ADDENDUM NO. 5

BAGGAGE EXPANSION

Northwest Florida Beaches International Airport
6300 West Bay Parkway
Panama City, Florida 32409
Phone: 850-763-6751

Date of Issue: May 19, 2022

A-4.0.1

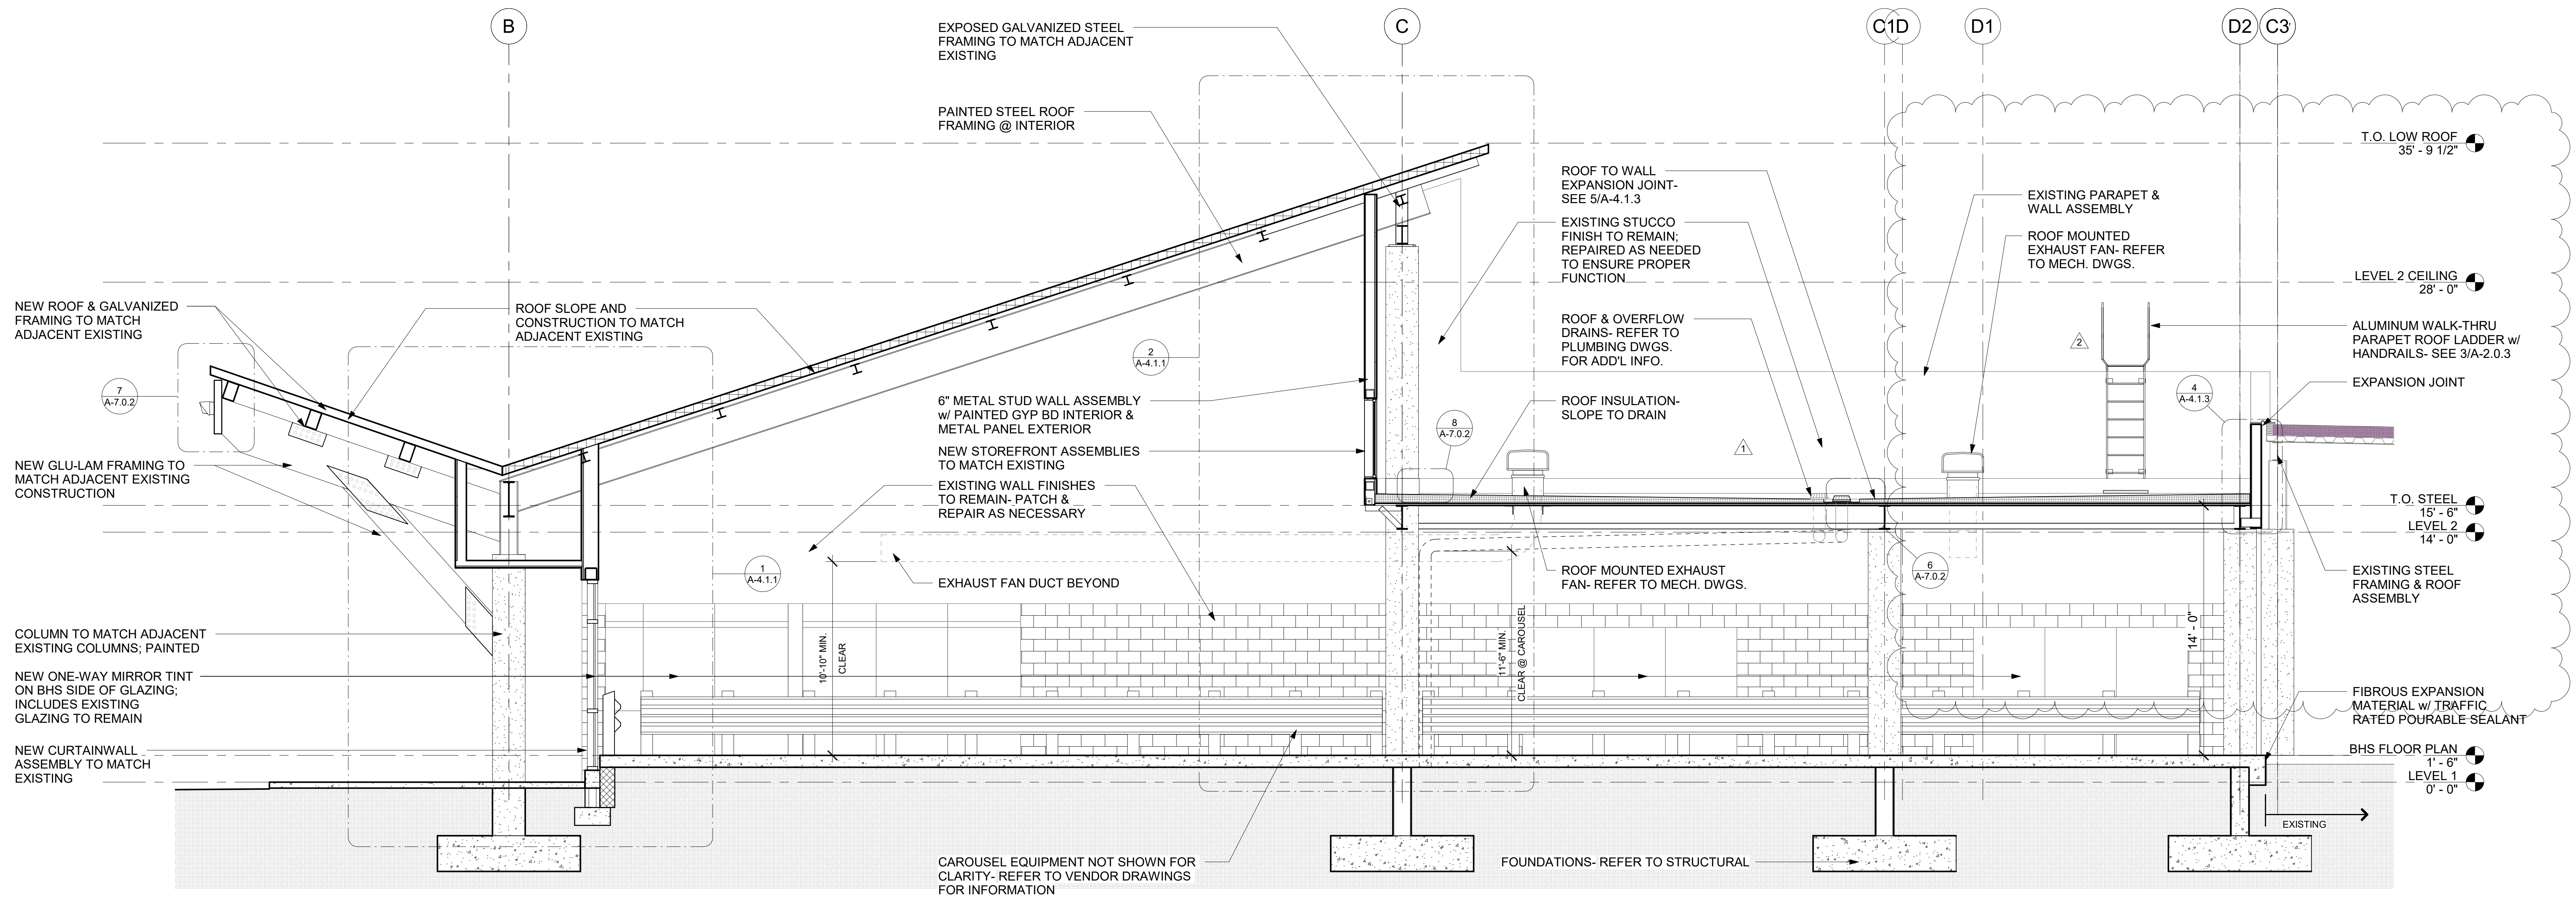
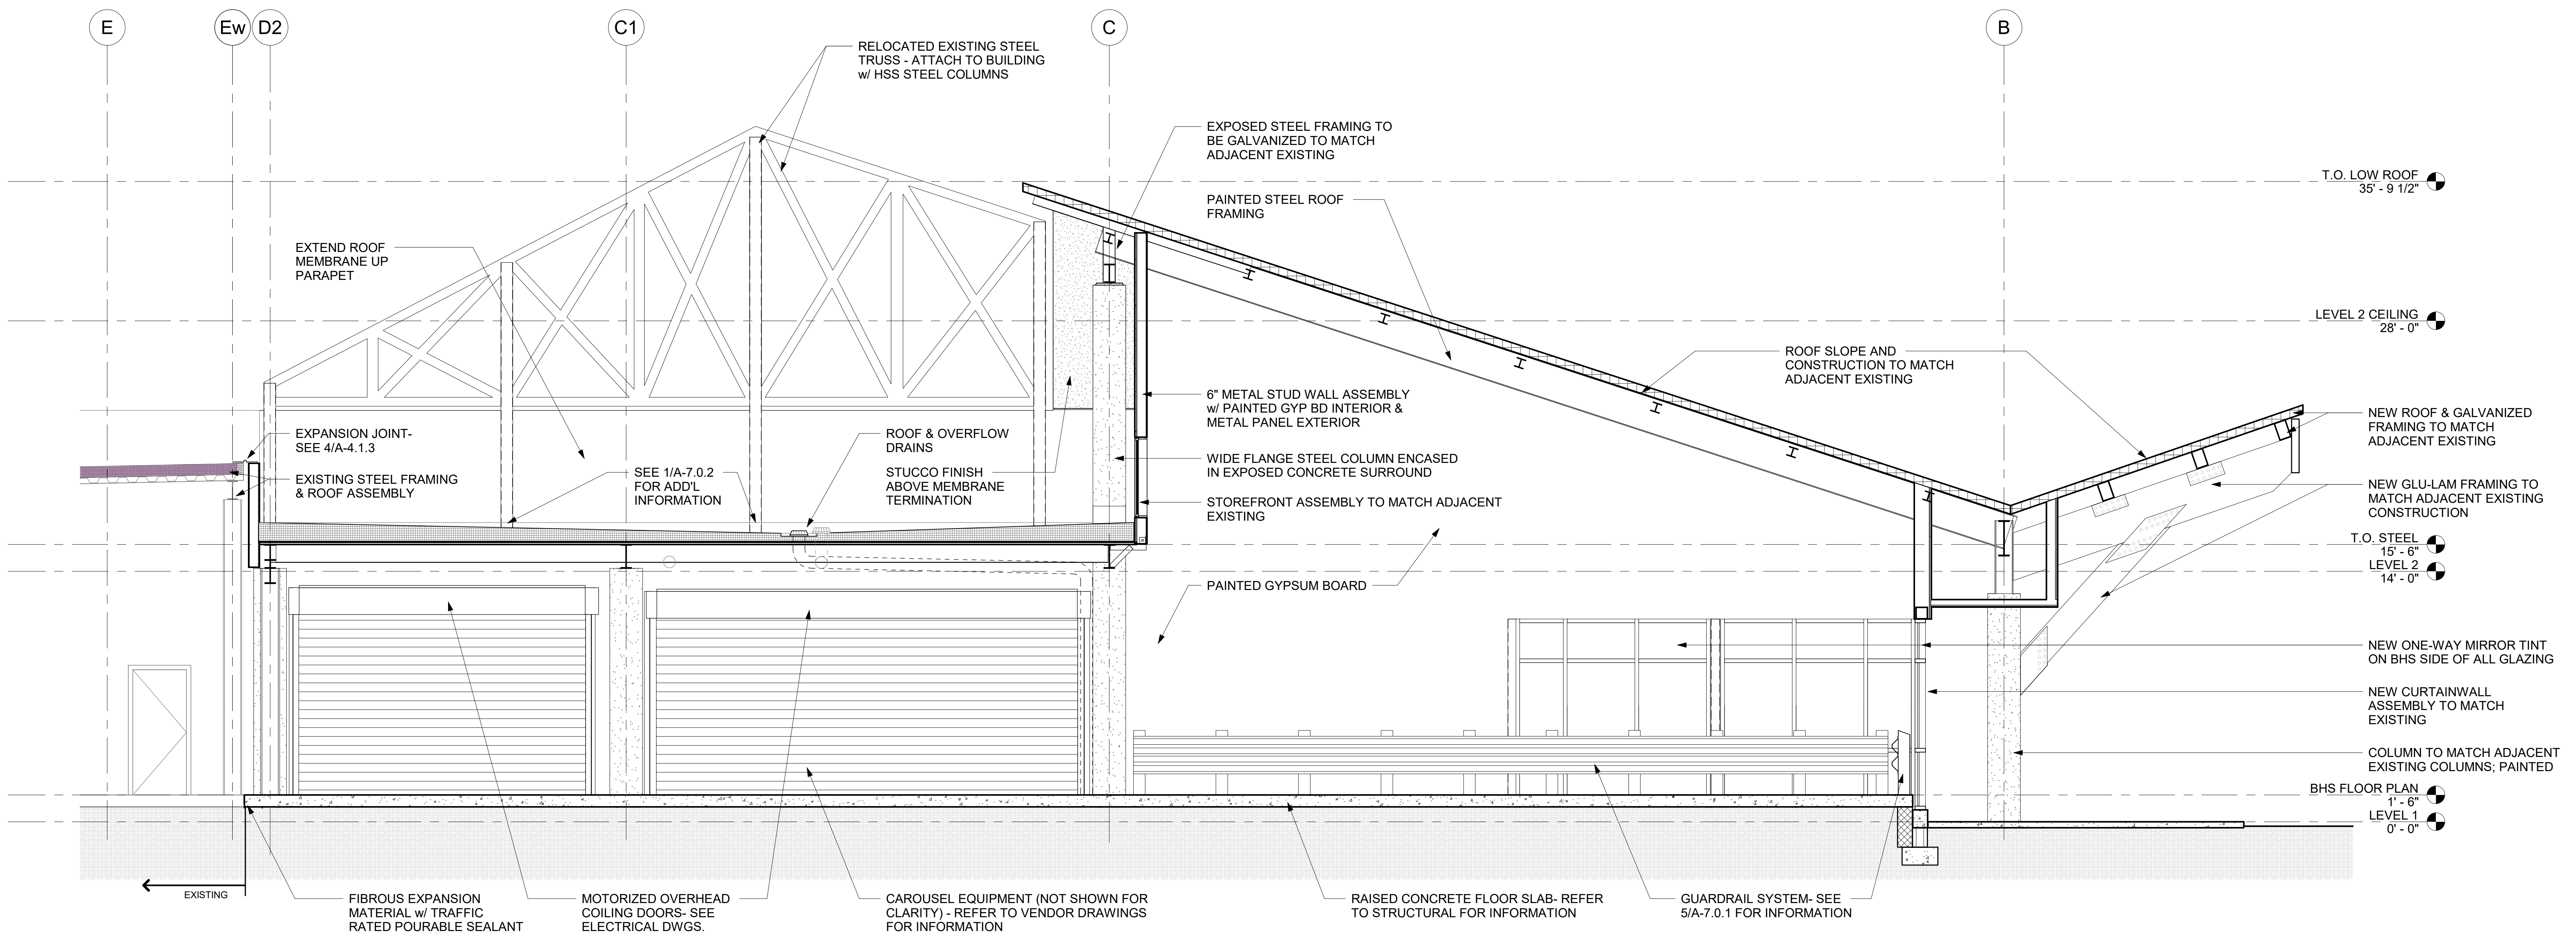
- A. ARCHITECTURE
 - a. REVISED: A-2.0.2 FLOOR PLAN, amend notes re: concrete floor sealer and rubber wall base
 - b. A-2.0.3 ROOF PLAN, added parapet roof ladder, added parapet roof ladder detail
 - c. REVISED: A-4.0.1 BUILDING SECTIONS, added parapet roof ladder
 - d. REVISED: A-4.0.2 BUILDING SECTIONS, added parapet roof ladder, revised/added GRV units to rooftop for clarity
